Wisconsin Department of Transportation

Proposal #18: 4140-20-73, WISC 2016 022
Green Bay Road, City of Sturgeon Bay
Michigan Street – Egg Harbor Road
STH 42/57
Door County

This is Addendum No. 1, which provides for the following:

ADDENDUM NO. 01

OVERHEAD CANTILEVER SIGN STRUCTURE DETAIL

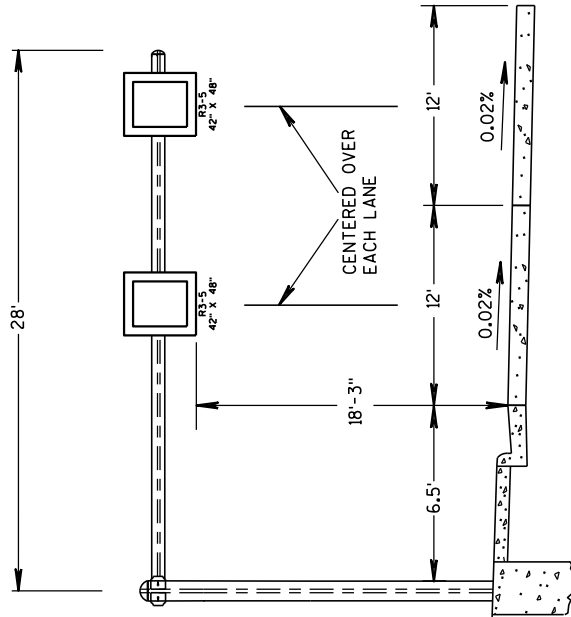
Added Plan Sheets	
Plan Sheet	Plan Sheet Title (brief description of why sheet was added)
110A	Construction Detail (dimensioning of overhead sign supports clear zone width and structure arm length)

Added: 110A
